Caroline Thomas Jacobs, Director
Office of Energy Infrastructure Safety
California Natural Resources Agency
715 P Street, 20th Floor
Sacramento, CA 95814

SUBJECT: First Supplement to Southern California Edison Company's 2022 Wildfire Mitigation Plan Update

SUMMARY OF CHANGES TO THE 2022 WMP UPDATE

Risk Assessment and Mapping – Additional weather scenarios and granular fuel data

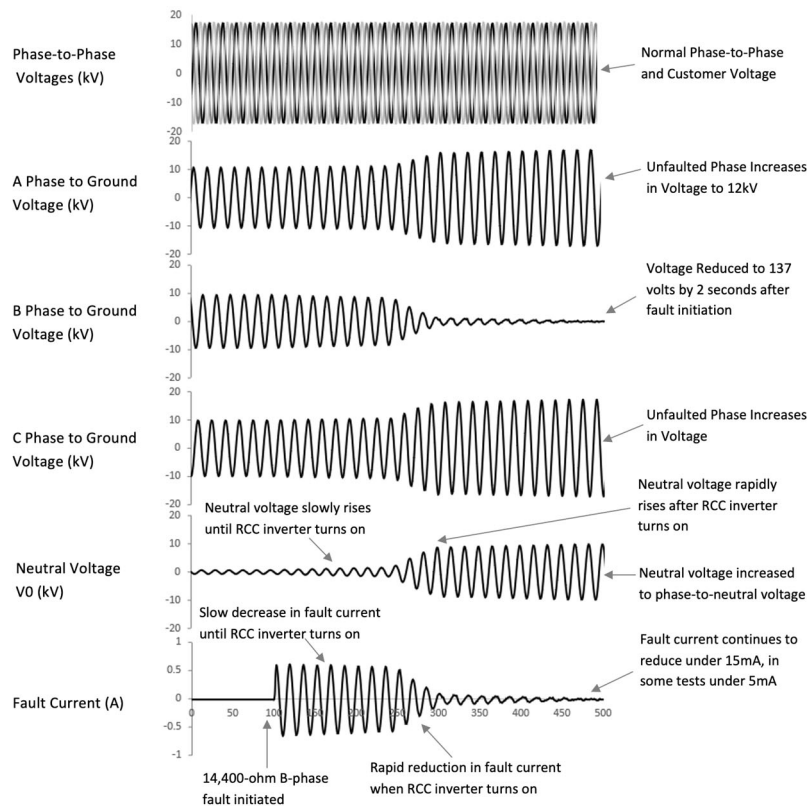
Risk Assessment and Mapping	Additional weather scenarios and granular fuel data	In the prior version of the Technosylva Wildfire Risk Reduction Model (WRRM), SCE utilized 41 weather scenarios. Similarly, SCE used fuels data accounting for present fuel conditions. SCE determined that a wider range of both fuel and wind driven conditions was needed for its risk modeling.	In 2021, SCE added an additional 400+ weather scenarios to better represent a wider range of both fuel and wind driven fire conditions. Similarly, SCE incorporated a more granular fuel model to account for fuel regrowth in recently burned locations with fuel regrowth projected out to the year 2030.
-----------------------------	---	---	---

- Please refer to SCEs 2022 WMP Figure SCE 4-5 (pg. 45) for a visual/graphical representation of Additional weather scenarios and granular fuel data.

Situational Awareness – Longer evaluation periods for weather modeling enhancements (SA-3)

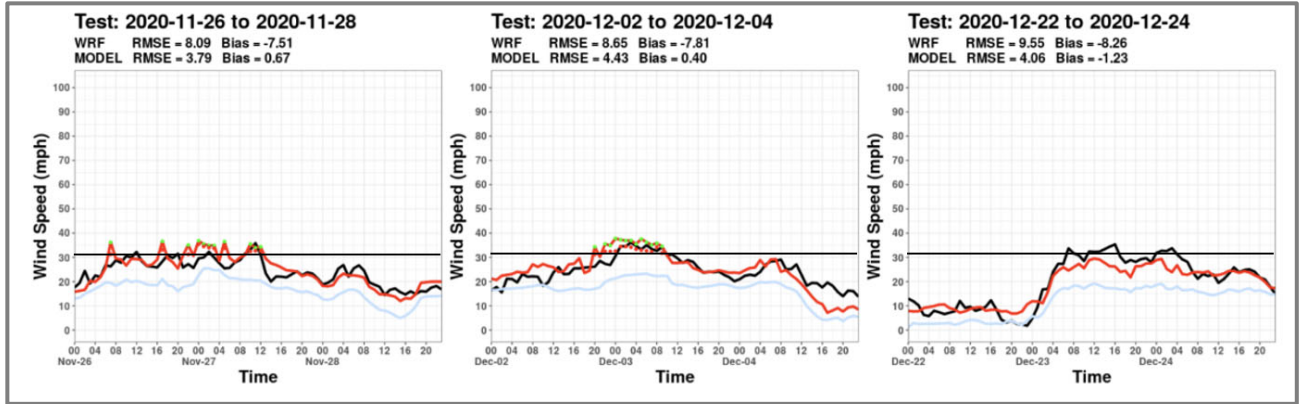
Situational Awareness	Longer evaluation periods for weather modeling enhancements (SA-3)	PSPS customer notifications are based on weather modeling. More accurate weather modeling will improve the accuracy of customer notifications. However, enhancements to the models require time to properly test and evaluate before incorporating into operations. In 2020 and 2021, SCE made substantial improvements to the modeling, but needed more time to test before operationalizing the enhancements.	SCE will be deploying ML capabilities on 500 weather stations and is building earlier deadlines into its scope of work prior to the start of the 2022 fire season to provide for a longer evaluation period. The evaluation will include new verification statistics and more tailored output.
-----------------------	--	---	--

- **Description:** As provided in the Figure, the machine learning forecast (red) has been demonstrated to be effective at removing forecast biases present in raw weather model forecast (blue) when compared to available observations (black).

Grid Design and System Hardening – Vibration Damper Retrofit

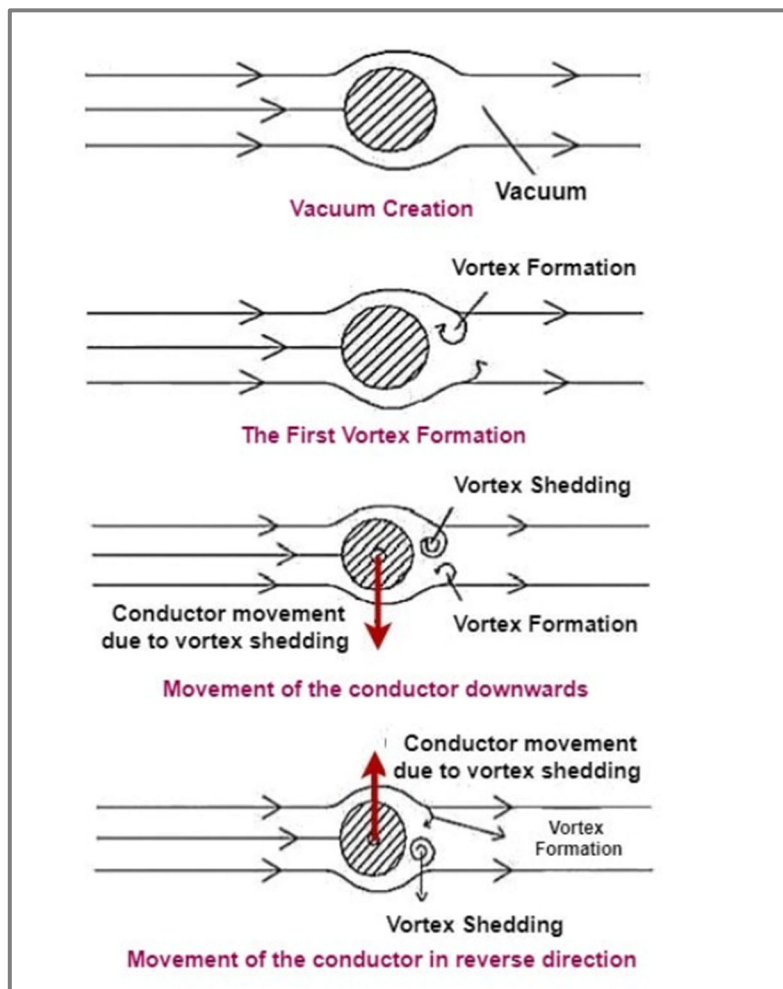
Grid Design and System Hardening	Vibration Damper Retrofit (SH-16)	A study was conducted to determine the susceptibility of the 2018 to 2020 covered conductor installations to Aeolian vibration.	SCE included a new activity in the 2022 WMP for Vibration Damper Retrofit to retrofit prior covered conductor installations with dampers designed to stop wind-driven Aeolian vibration that may lead to conductor abrasion or fatigue over time.
----------------------------------	-----------------------------------	---	---

- Description:** The graphic illustrates the mechanism of Aeolian vibration. However, for more information on Aeolian vibration and vibration dampers, please refer to the following report: https://www.preformed.com/th/images/pdfs/Energy/Transmission/EN-ML-1007-4_Aeolian_vibration_basics.pdf

Grid Design and System Hardening – Secondaries

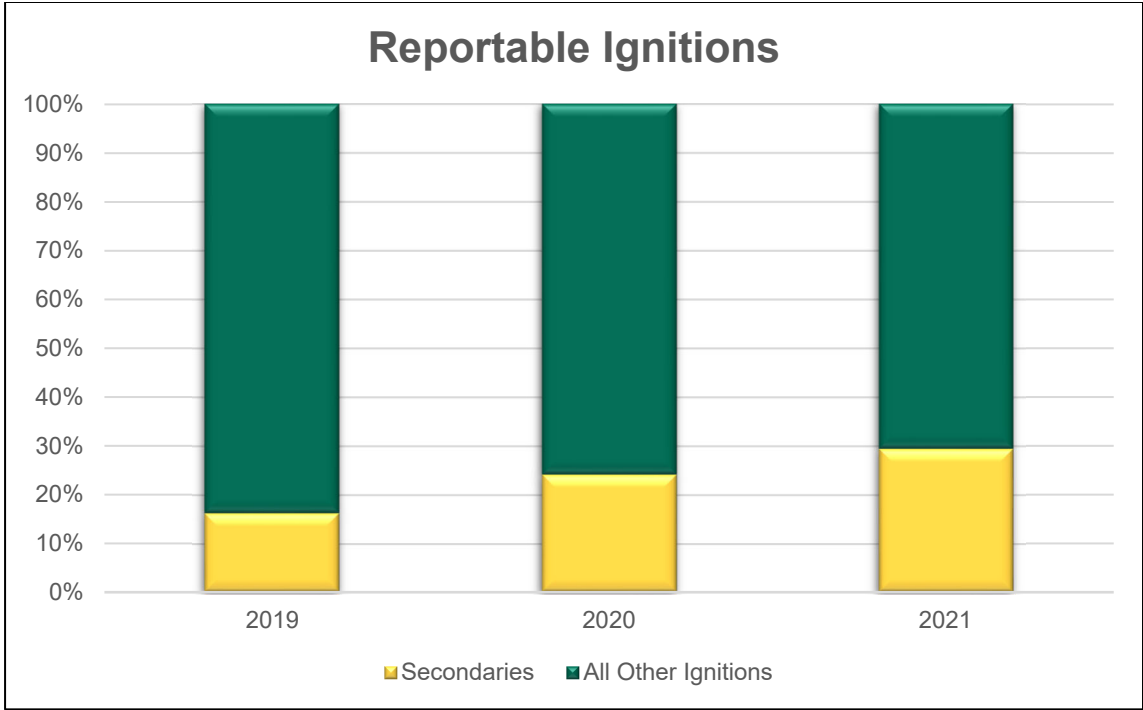
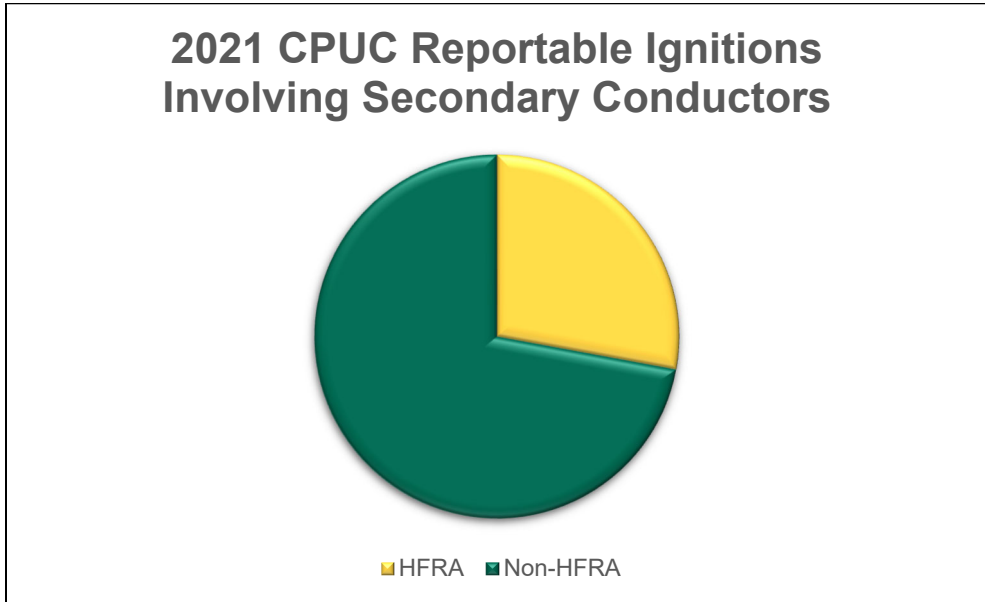
Grid Design and System Hardening	Secondaries	<p>Between 2019 and 2021 there have been 99 California Public Utilities Commission (CPUC)-reportable ignitions where Secondary conductor is listed as the "Root Cause Equipment." Approximately 30% of CPUC-reportable ignitions in 2021 involved secondary conductors across SCE's service territory, with approximately 25% of these ignitions occurring in HFRA.</p>	<p>SCE is mitigating high risk secondary conductor locations, including remediating connectors and inspecting and trimming vegetation. SCE is also developing a long-term secondary connection covering to replace taping and is evaluating a breakaway that disconnects and de-energizes service and secondary connector at a predetermined mechanical load, which prevents ignitions if the wires fall due to fallen trees or excessive winds.</p>
----------------------------------	-------------	--	--

- **Description:** The below graph illustrates CPUC reportable ignitions from 2019-2021, split by those associated with secondary conductor and all other ignitions.

- Description:** HFRA vs non-HFRA secondary caused ignitions that occurred in 2021.

Asset Management – Decrease in Distribution / Transmission HFRI inspections find rates (IN-1.1 and IN 1.2)

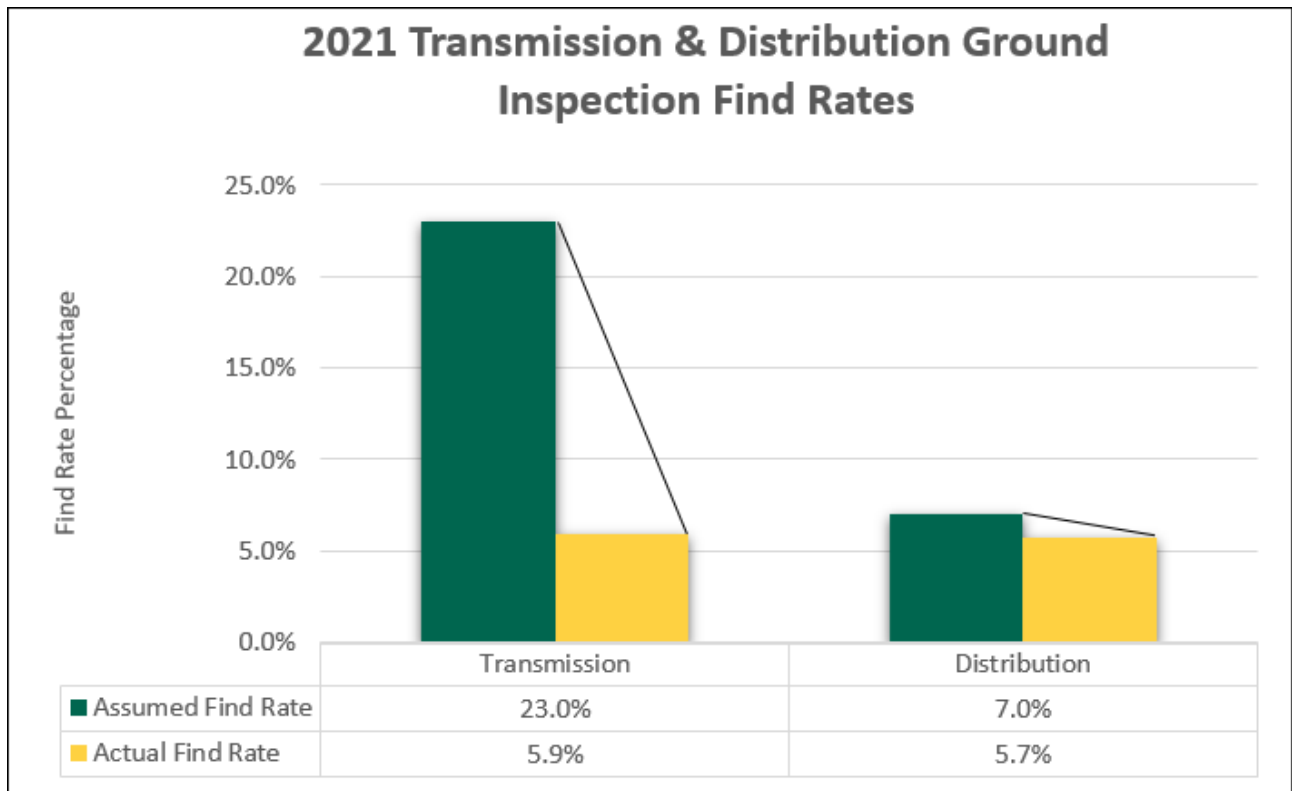
Asset Management and Inspections	Decrease in Distribution / Transmission HFRI inspections find rates (IN-1.1 and IN-1.2)	SCE relied on historical find rates (i.e., the percentage of inspections that identify the need for a remediation) to forecast the remediation portion of HFRI inspections for the 2021 WMP. Notably, the assumed find rate for Distribution HFRI ground inspections in the 2021 WMP Update was 7.0%, based on inspections as of mid-year 2020. The actual find rate in 2021 has since come down to 5.7%.	SCE is assuming the lower find rate for planning purposes. This can reduce the number of contractors required to perform the work and allow for deployment of resources to other risk mitigation activities. SCE balances these opportunities with the potential for additional work that may result from changes or additions to the inspection form resulting from lessons learned throughout the year.

- **Description:** The below graph shows transmission & distribution ground inspection find rates for 2021.

Vegetation Management and Inspections – Decrease in Scale of Dead and Dying Tree Removal Program (VM-4)

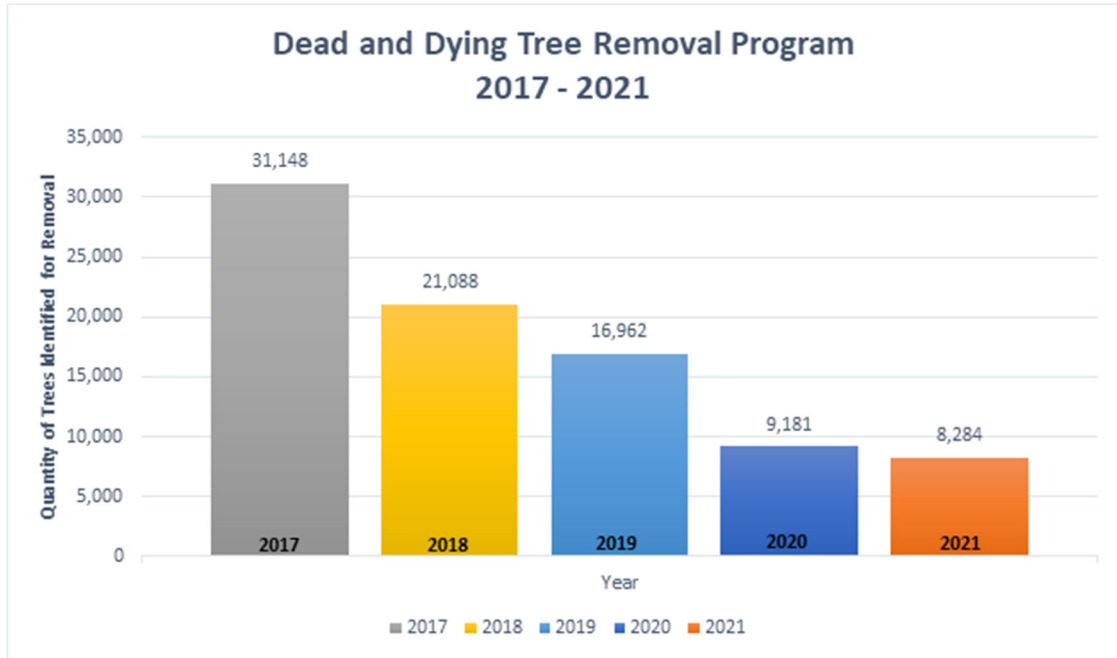
Vegetation Management and Inspections	Decrease in Scale of Dead and Dying Tree Removal Program (VM-4)	The decrease in scale of the Dead and Dying Tree Removal Program is primarily due to a lower than anticipated find rate of dead, dying, and diseased trees, resulting in less work needing to be completed. Circuit patrols continue to be performed as planned for the year, however, the volume of trees in need of removal is lower than anticipated.	SCE reduced its 2021 WMP Forecast to align with actual dead and dying tree find rate and will take its findings from 2021 into account in its 2022 WMP.
---------------------------------------	---	--	---

Description: Below is a chart that illustrates the decrease in the quantities of trees identified for removal in the Dead and Dying Tree Removal Program from 2017 to 2021.
